PIC16(L)F1615/1619 Family Silicon Errata and Data Sheet Clarification

The following typographic corrections and clarifications are to be noted for the latest version of the device data sheet (DS40001770A):

FIGURE 36-7: V_{OH} vs. I_{OH} OVER TEMPERATURE FOR HIGH DRIVE PINS, $V_{DD} = 5.0V$

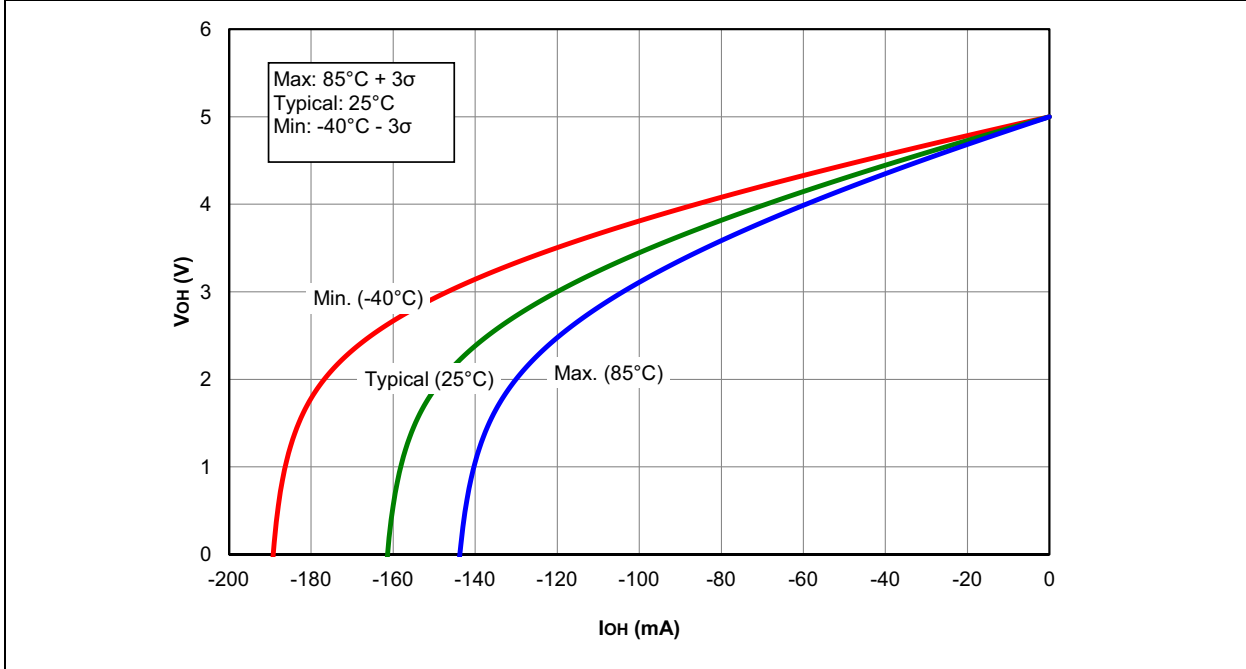
6. Module: DC and AC Characteristics Graphs and Charts

The following two graphs should be added to the graphs:
